EPRI (2004, 2006) Ground-Motion Model (GMM) Review Project

**Responses to NRC Review Questions
and Comments Dated July 3, 2013**

July 30, 2013

Figure 7.7.1-10
Within-cluster epistemic standard deviation of the median ground motions for Cluster 1

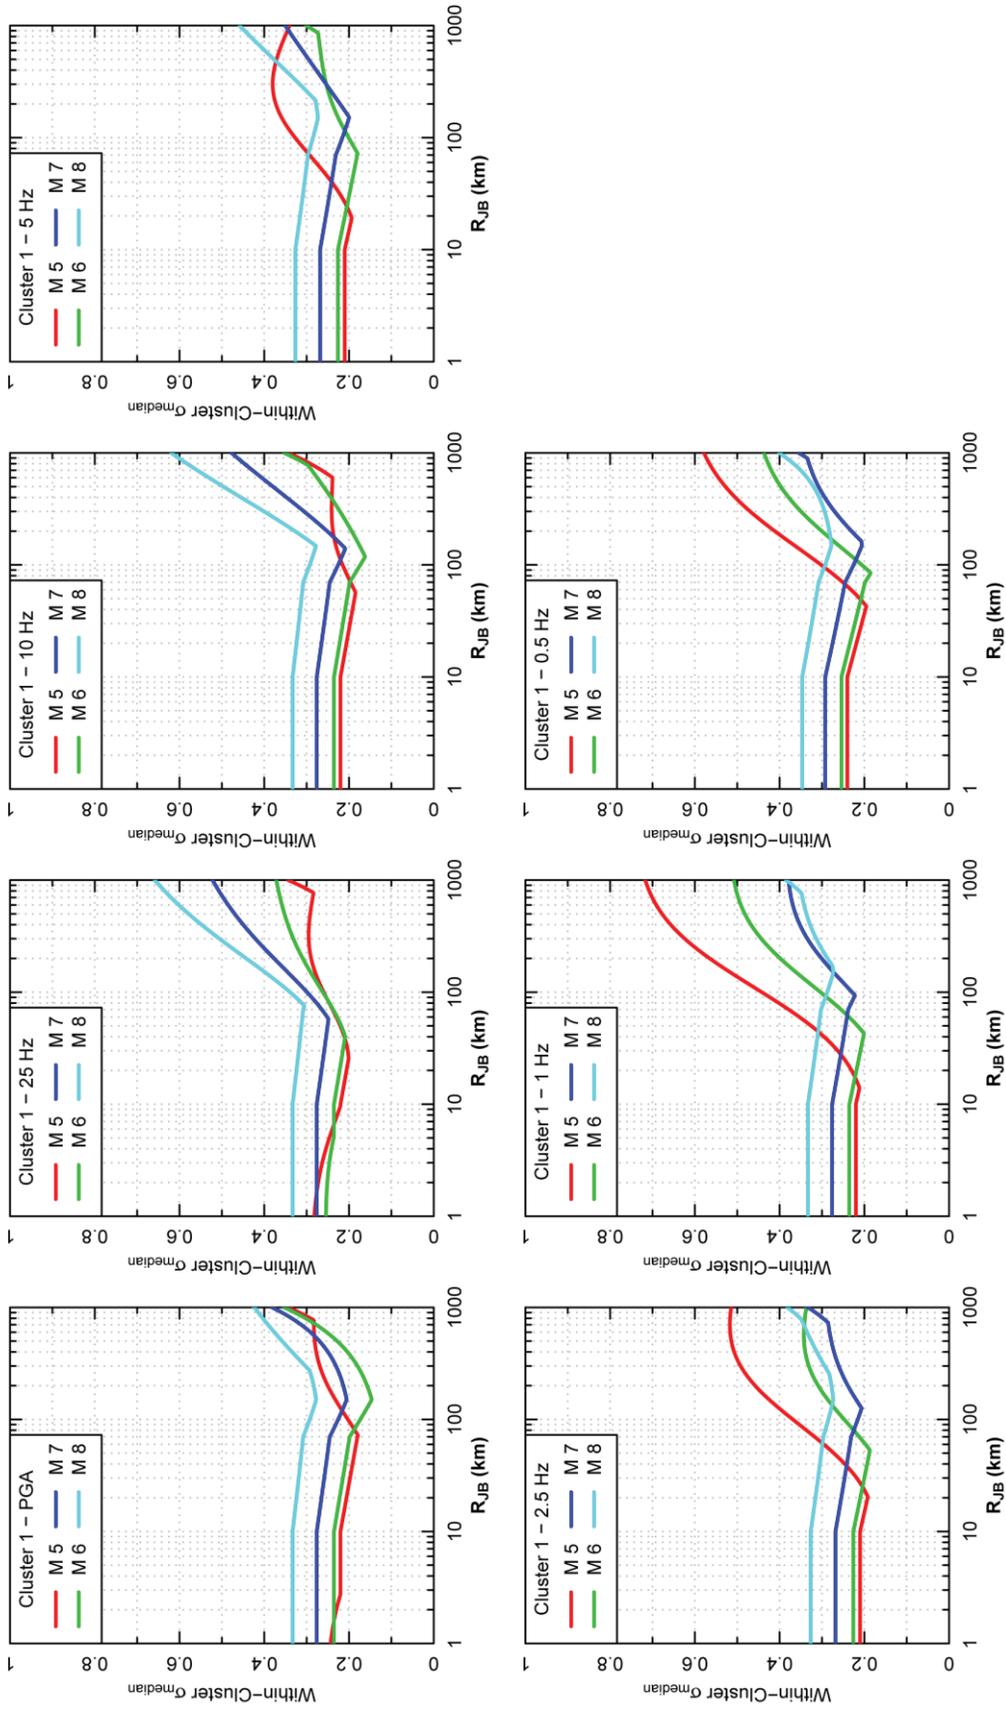
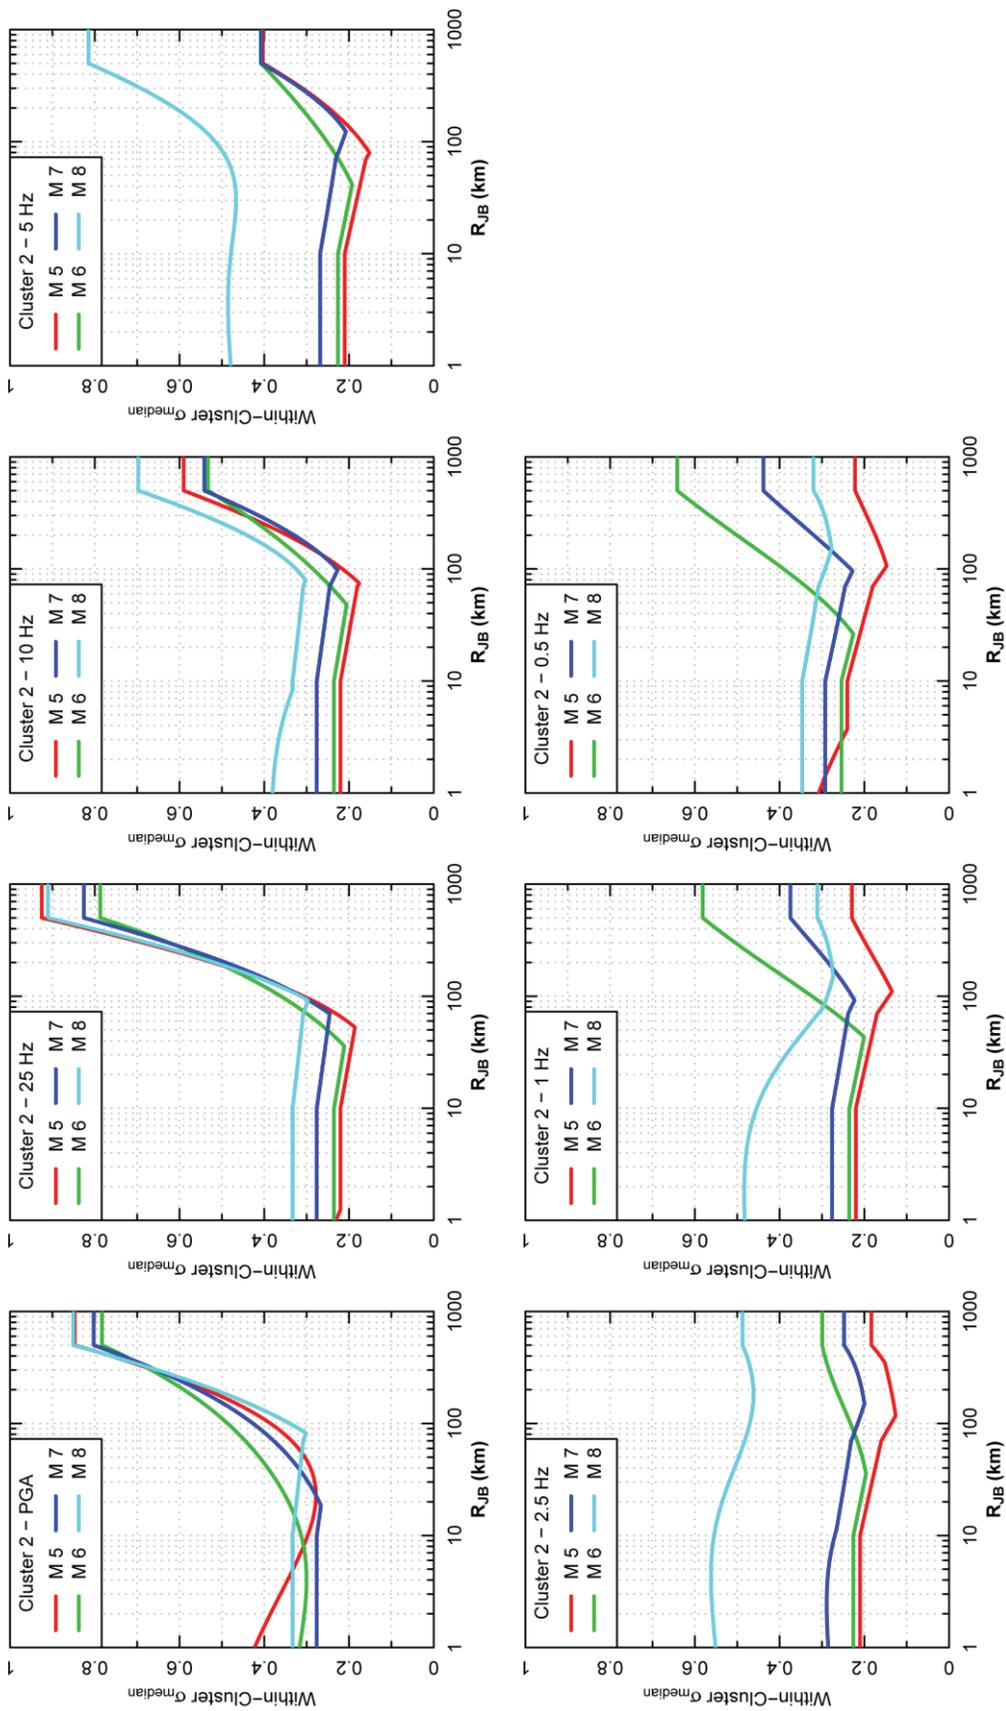
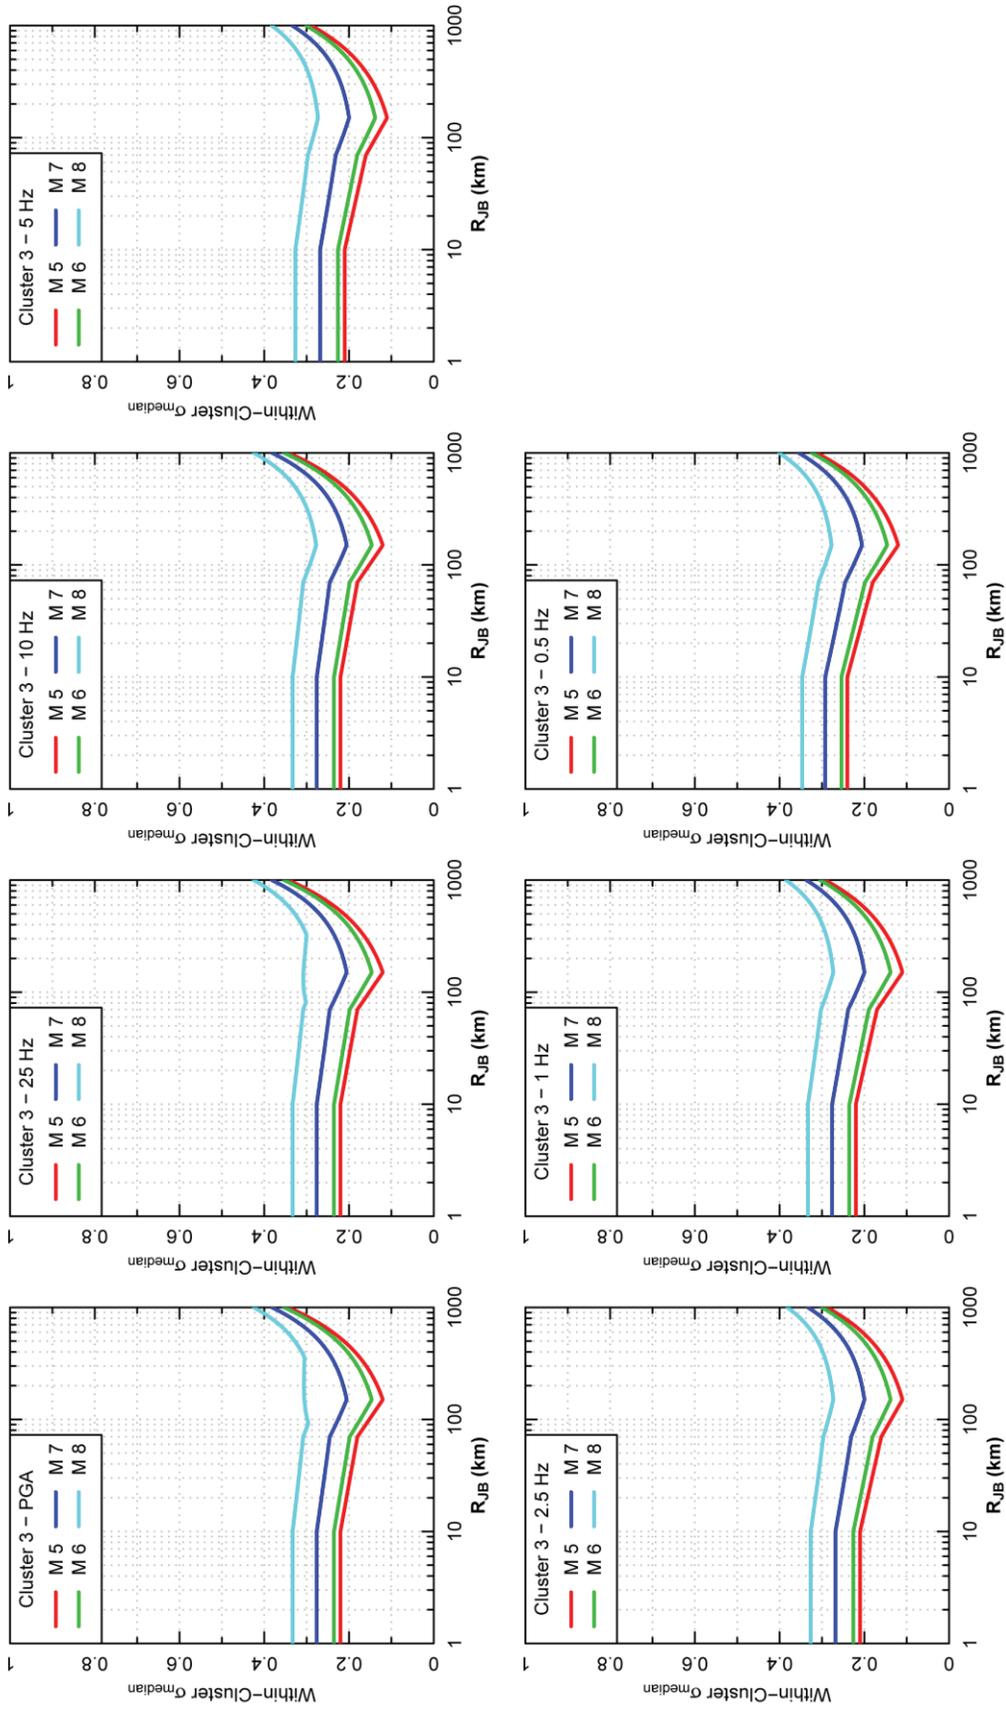
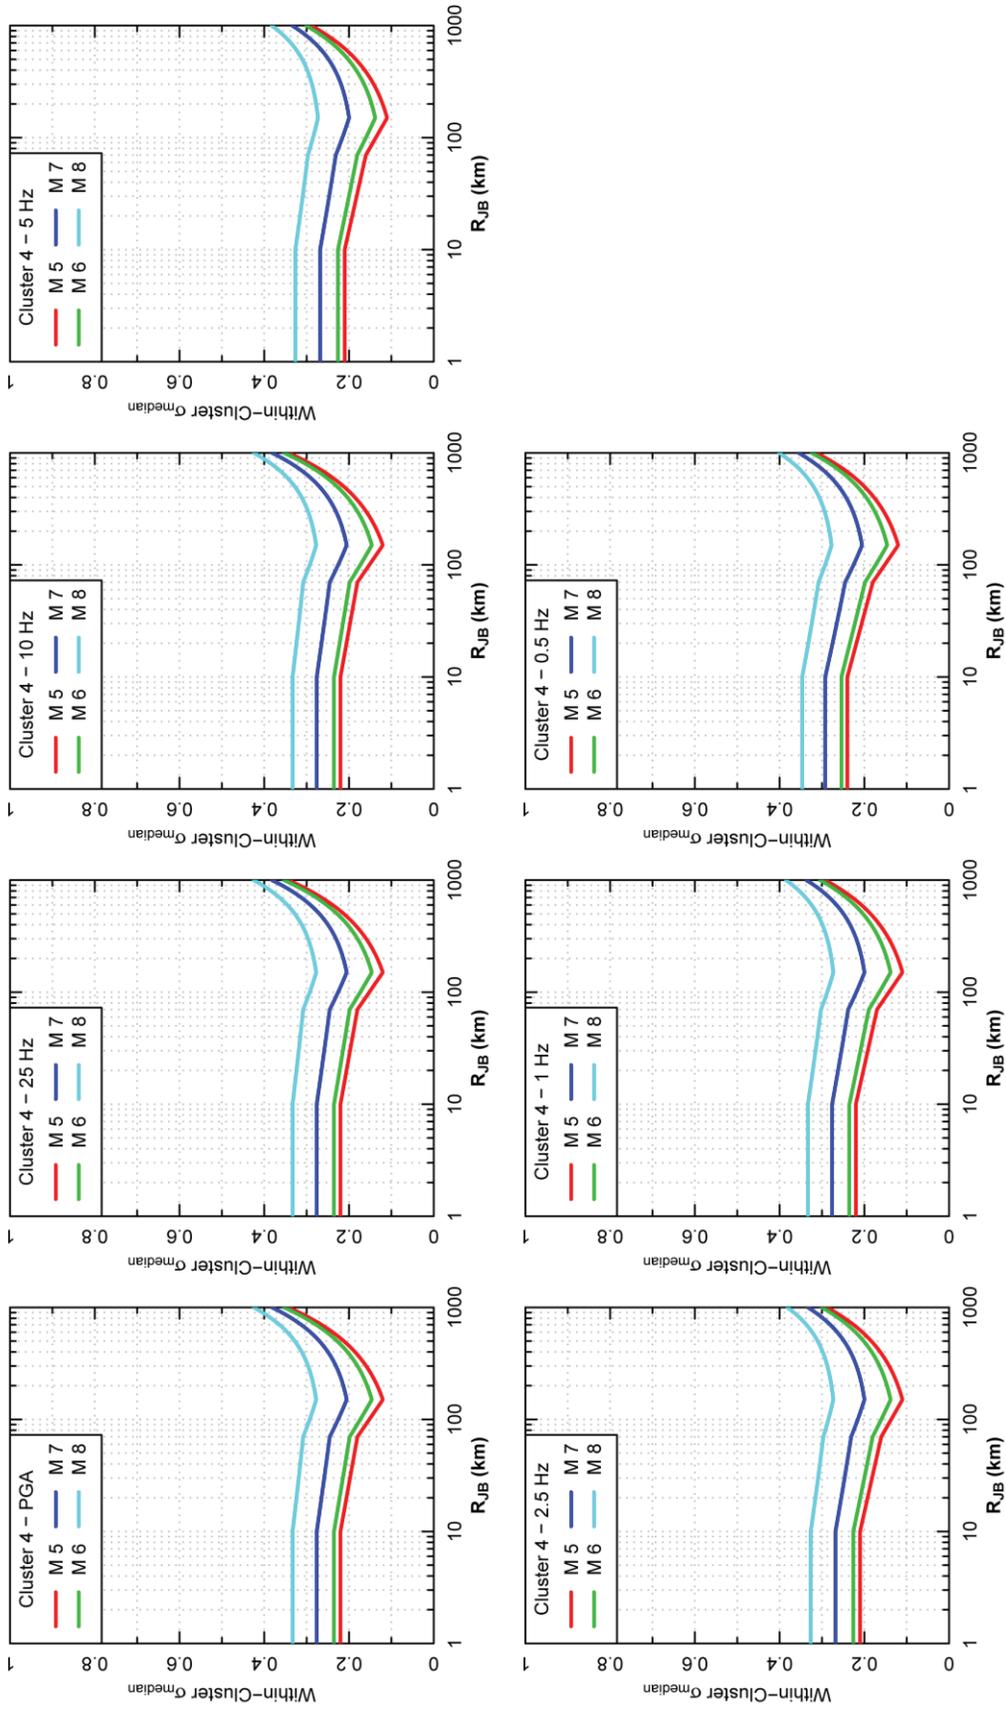
Question 7: Section 7.13 of the report provides sensitivity calculations to investigate the effects of a number of alternative assumptions. One alternative assumption that is not discussed is the overall impact of including additional uncertainty to account for magnitude scaling. Please provide a discussion of the relative importance of adding this factor, specifically with respect to the within-cluster epistemic uncertainty.

Comparing the within-cluster epistemic uncertainty on Figures 7.7.1-10 through 7.7.1-13 to Figure 7.7.1-9, one observes that for Clusters 1, 3, and 4, and for distances from 1 km to at least 100 km, the combined within-cluster epistemic uncertainty is being controlled by the cluster-independent epistemic standard deviation.

Examining the values on the figures discussed above, one can conclude that the effect of removing the magnitude-scaling uncertainty would have the following effects for Clusters 1, 3, and 4:

- A nearly magnitude-independent within-cluster epistemic uncertainty at distances from 10 km to 30 km.
- A reduction in the within-cluster epistemic uncertainty for **M** 7 and 8 at distances from 1 km to 30 km. For **M** 8, the size of this reduction is approximately 0.12 natural log units, which translates into a factor of approximately $\exp(-0.12 \cdot 1.645)$ or 0.82 on the high (or 95%) GMPE for each cluster, and a reciprocal factor of 1.22 on the low (or 5%) GMPE. Because this reduction affects only the 95% and 5% GMPEs, and because most of the hazard for exceedance frequencies of GMRS interest comes from lower magnitudes (particularly for high frequencies), the effect of this reduction is small.
